**EASTSOUND SEWER AND WATER DISTRICT
WASTEWATER TREATMENT PLANT UPGRADE – PHASE 2**

**ADDENDUM NO. 3 (22 pages total)
Issue Date: March 11, 2025**

SHEET
E3.2

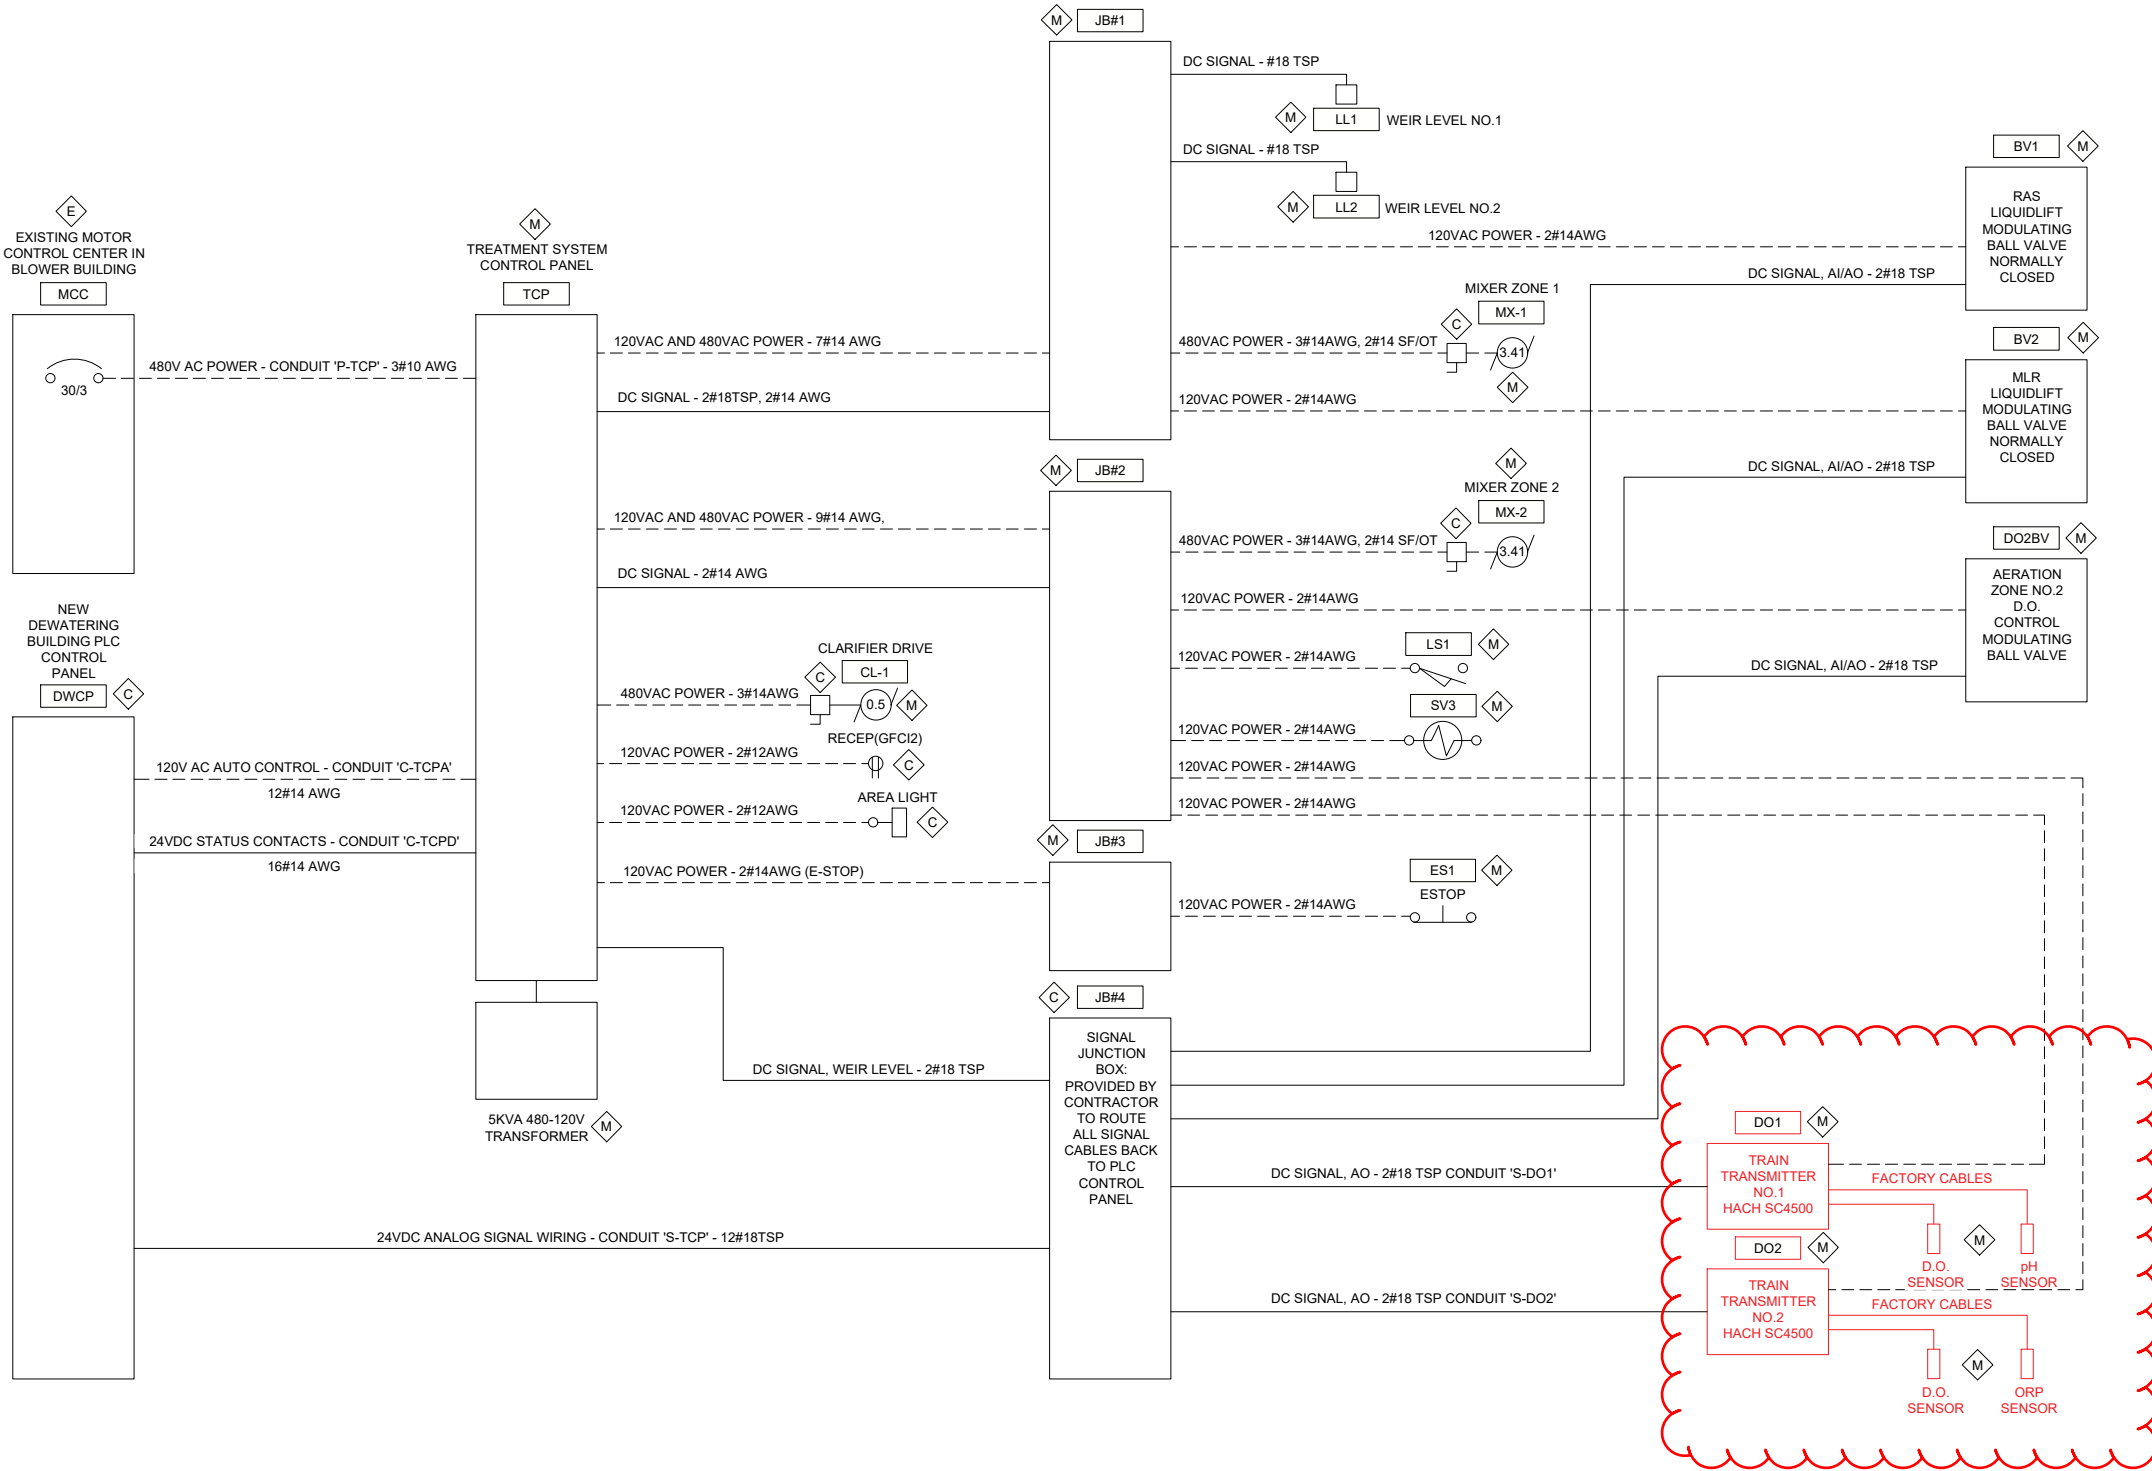
The interconnection diagram has been updated to indicate that the transmitters and instruments are provided by the treatment system provider for contractor installation, and the addition of the pH and ORP sensors.

SHEET	DATE	SCALE	JOB NUMBER
E7.6	01-24-2025	AS SHOWN	2023-123
PAGE	OF		
86	91

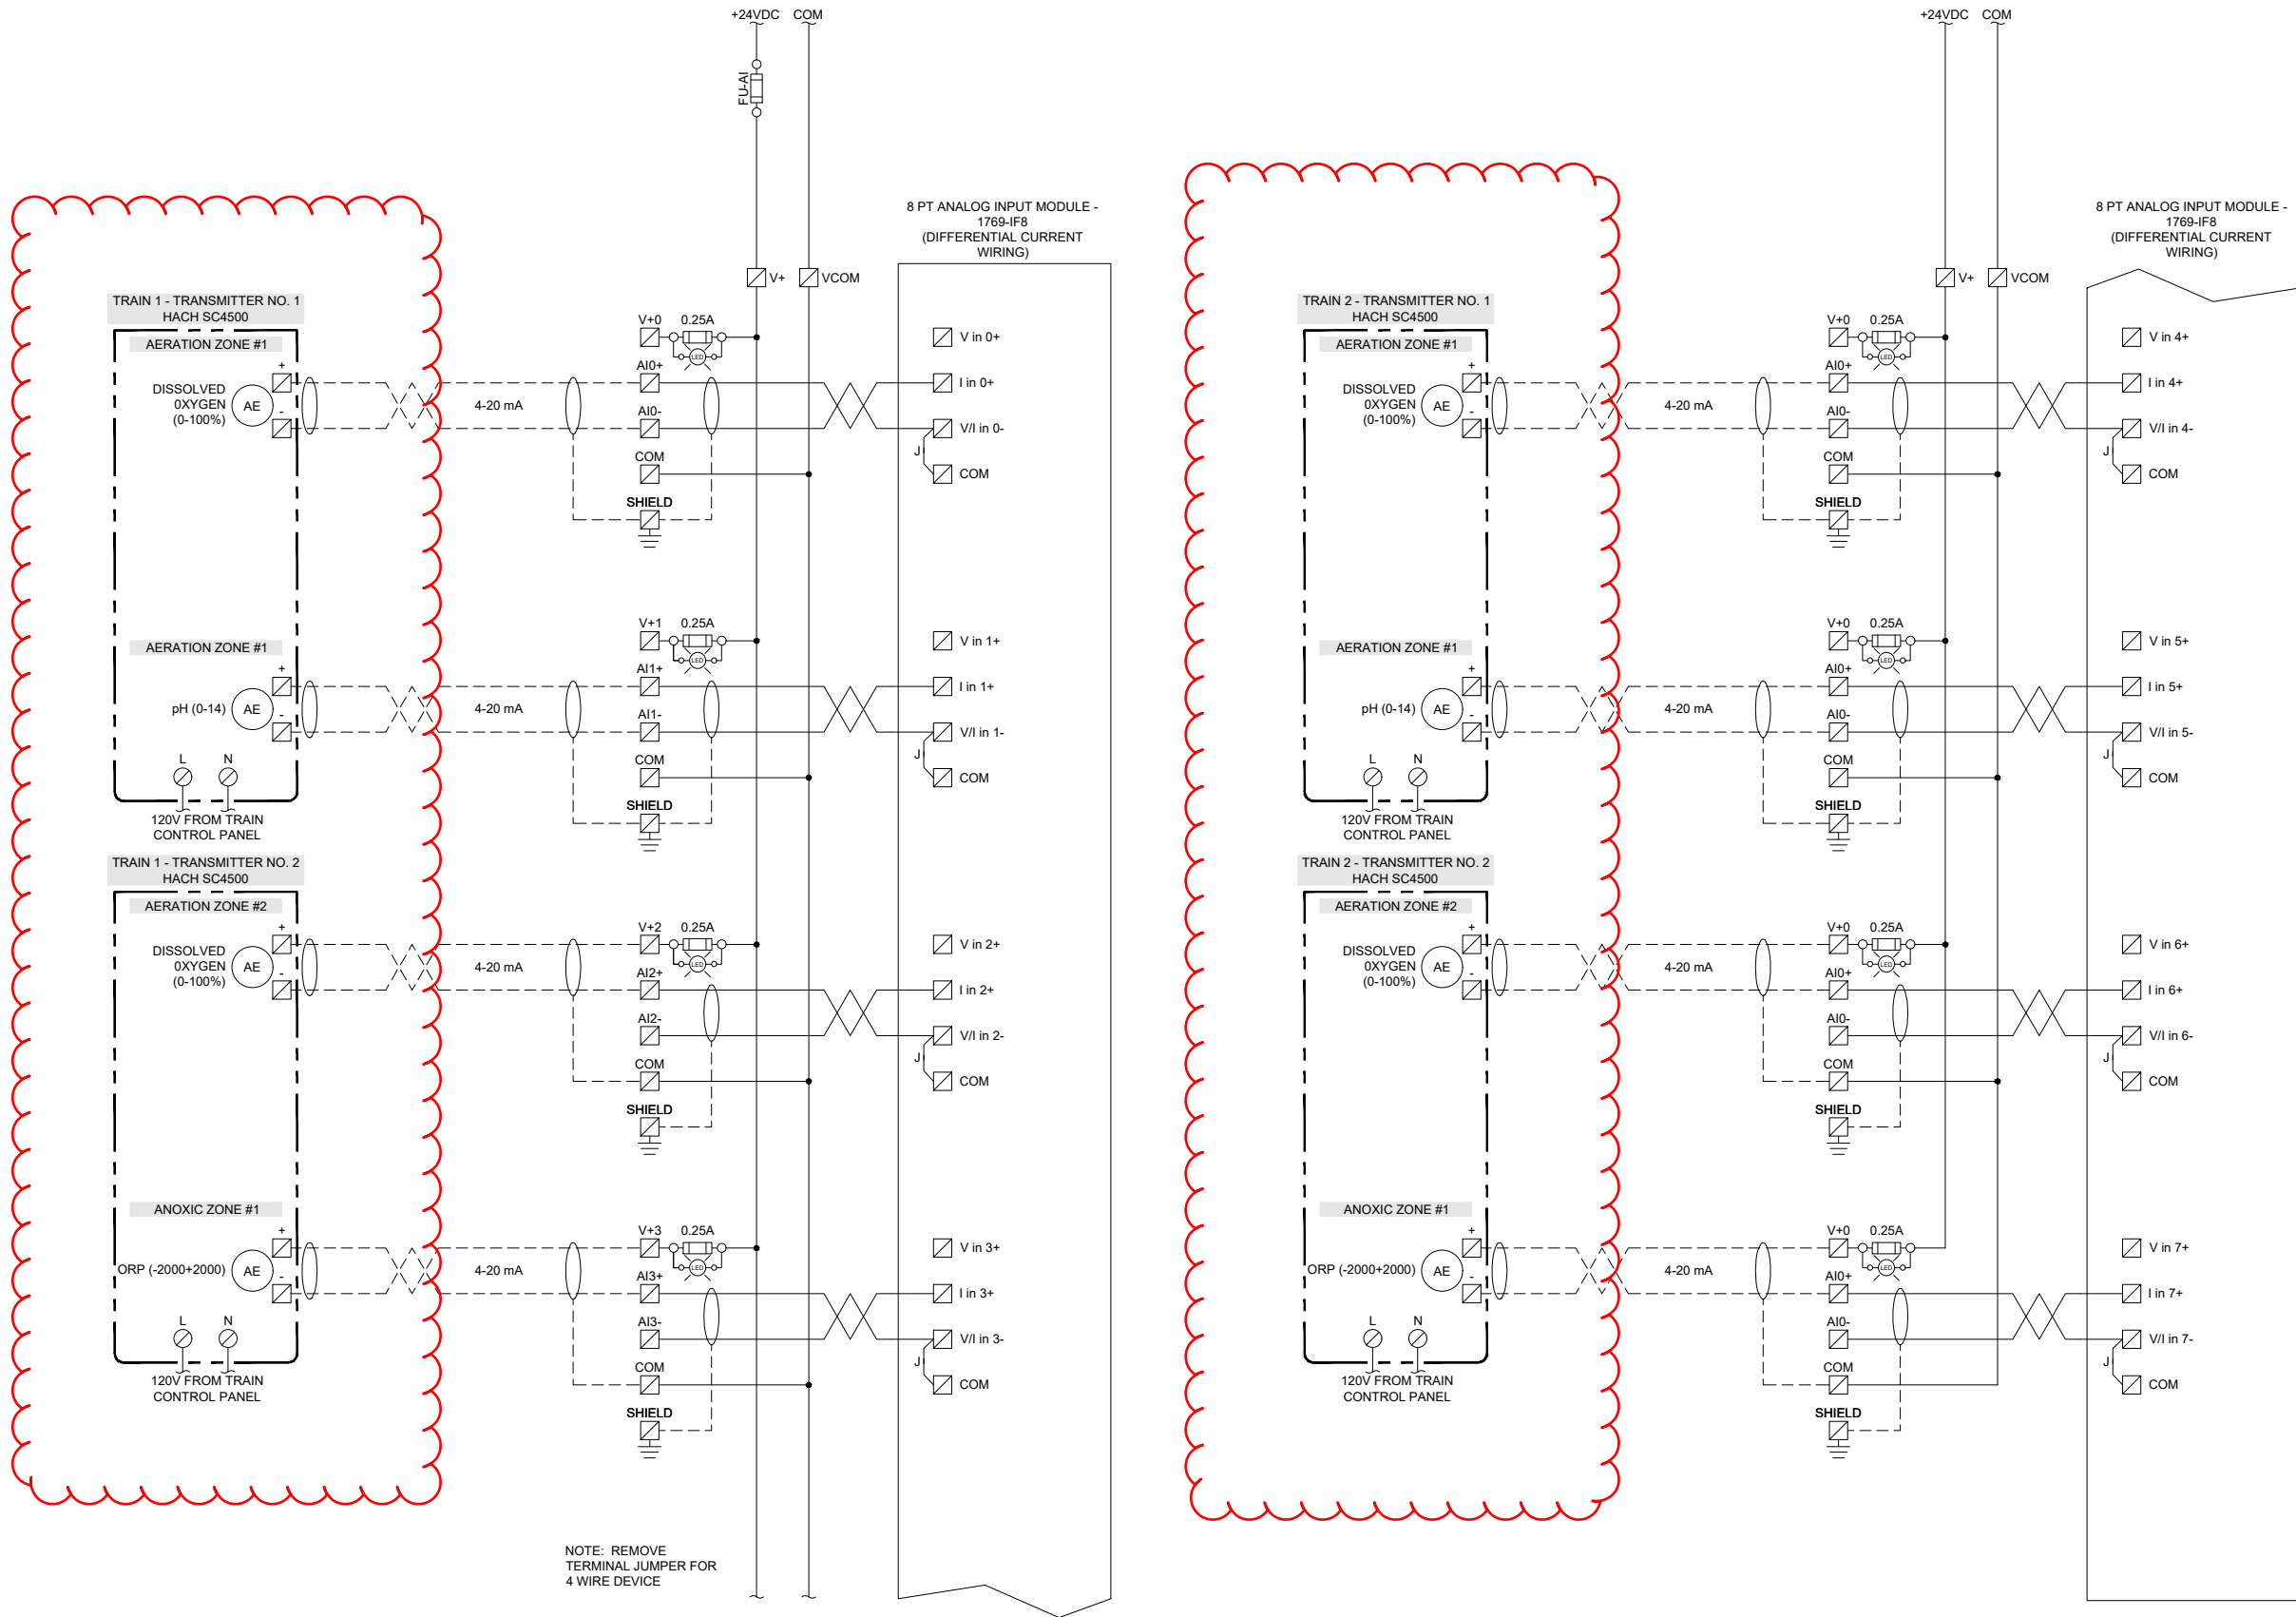
Analog input diagram updated for the pH and ORP sensors.

SHEET
E7.7

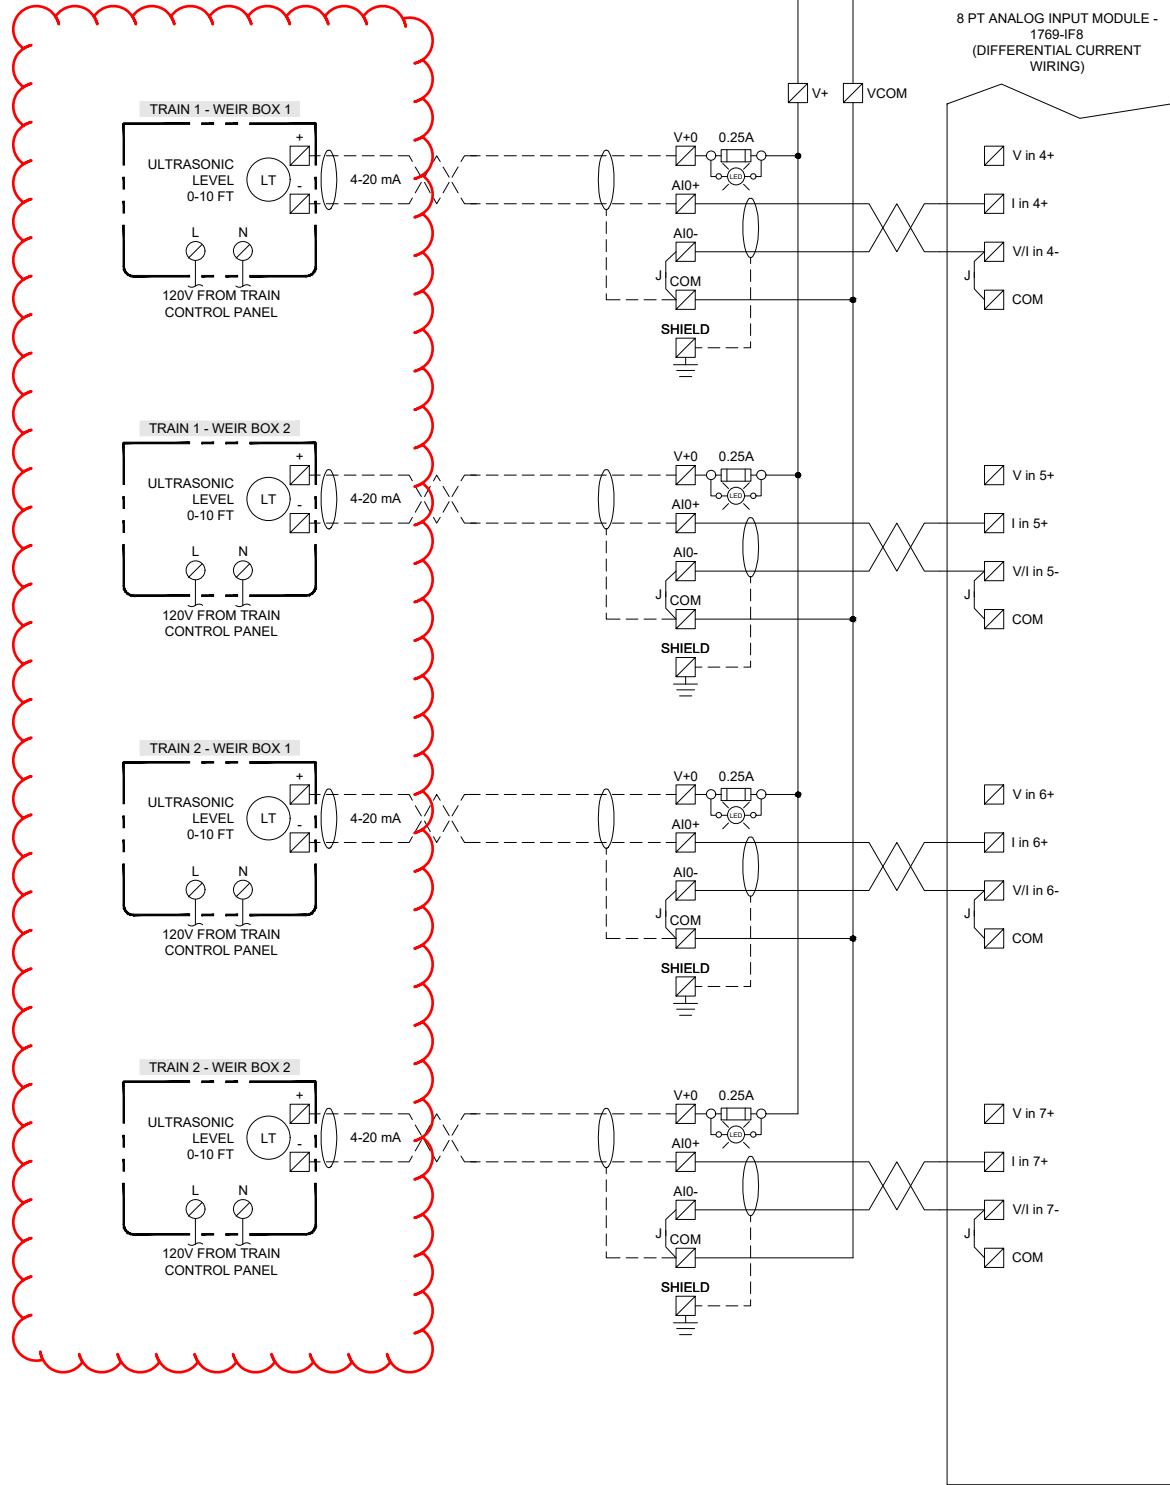
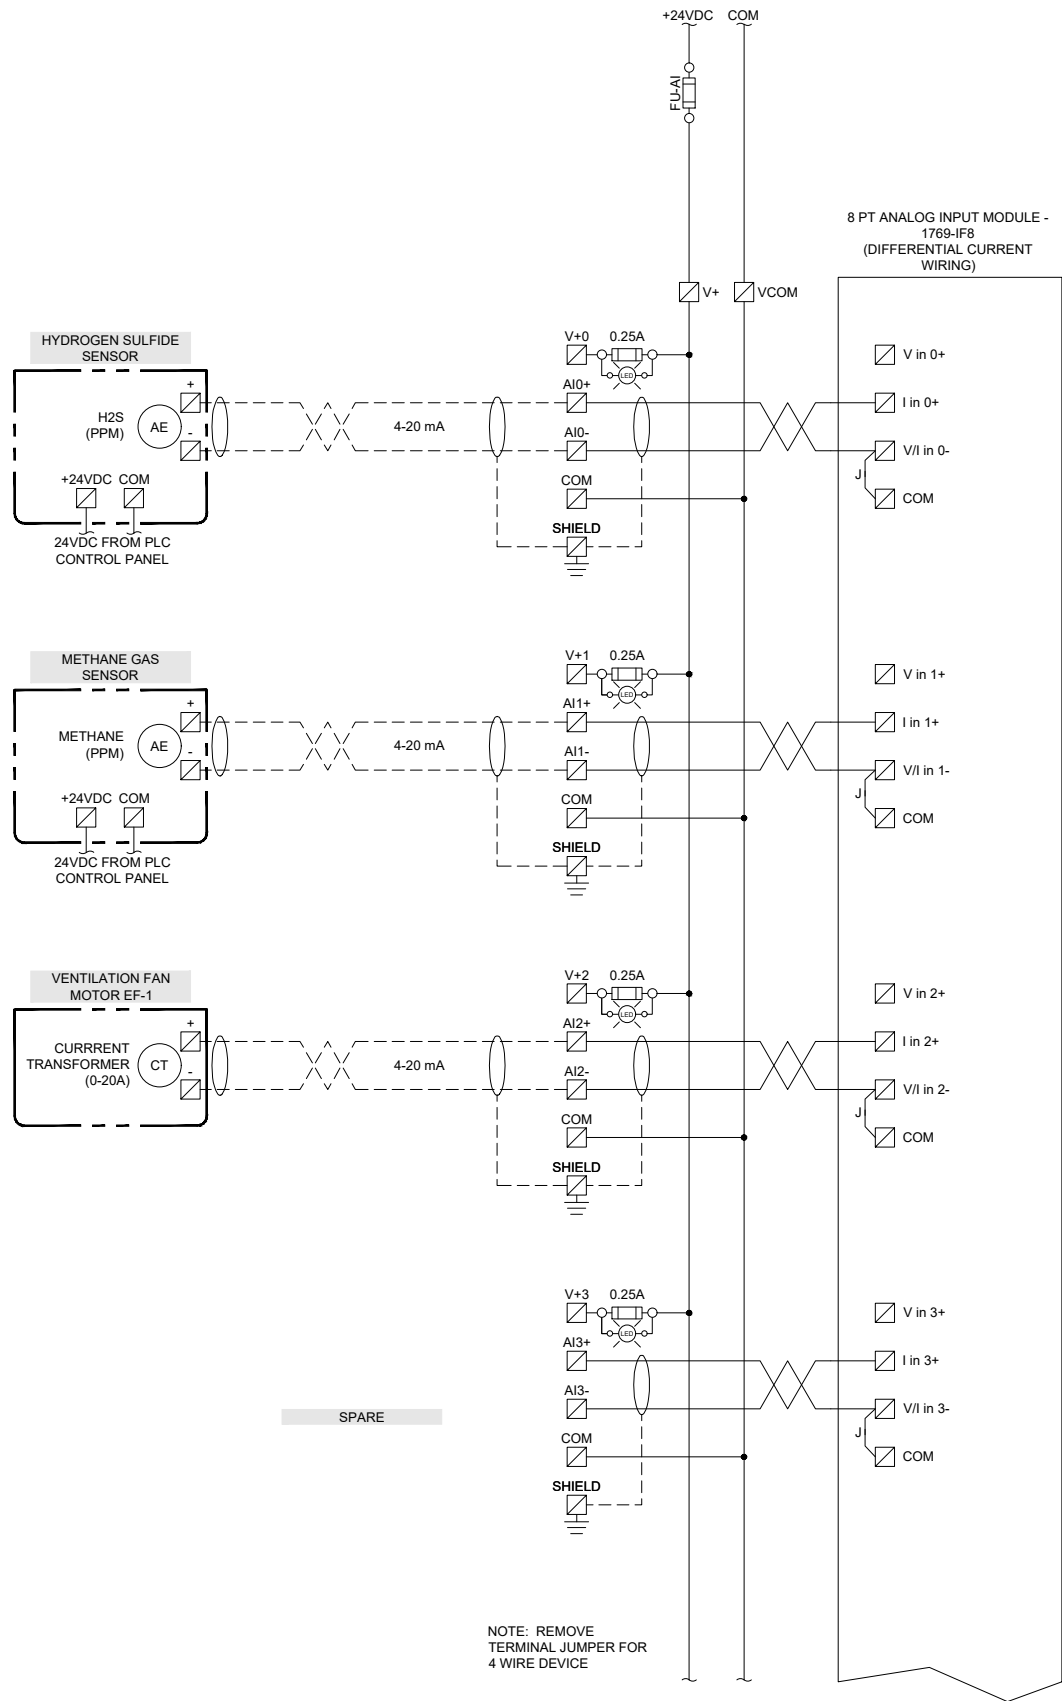
Analog input diagram re-arranged due to the pH and ORP sensors.
